MEMORANDUM

TO: District of Columbia Zoning Commission

DATE: June 19, 2015

SUBJECT: ZC #15-10 - Setdown Report - Consolidated PUD and Related Map Amendment from the C-M-1 District to the R-5-B District (Square 5197, Lot 809) (Deanwood Hills)

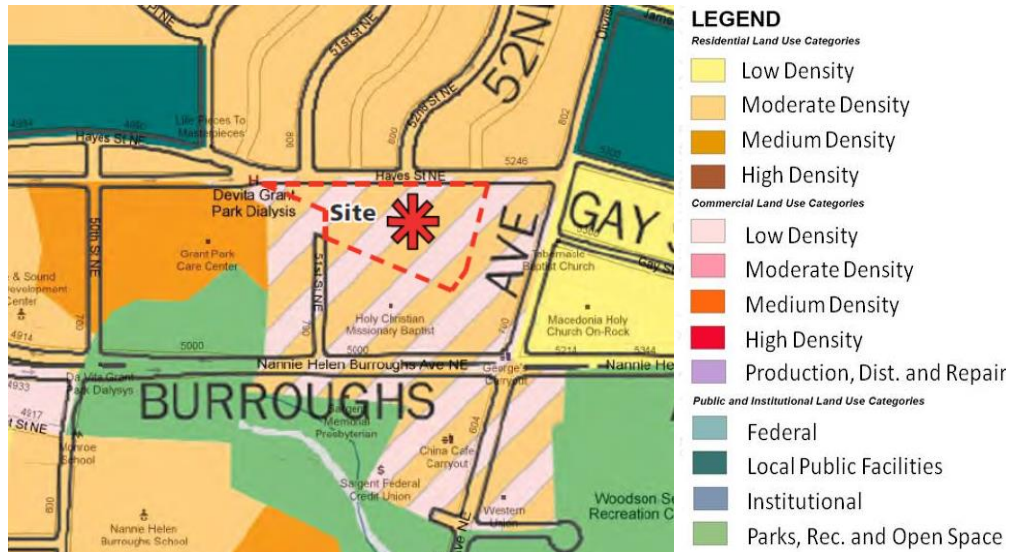
A new retaining wall (maximum height -12 feet) with guardrails would be constructed along the rear property line, which would separate the surface parking area for the existing church to the south and the proposed parking area within the project site (Exhibit A3- Sheet L06). Bio-retention areas would be placed within landscaped islands in the parking area and native plantings and shade trees are shown in some portions of the perimeter of the parking lot. Secured bicycle parking would be provided within the building's basement for up to 50 bikes. Additional details regarding the design of the retaining wall are needed prior to a public hearing.
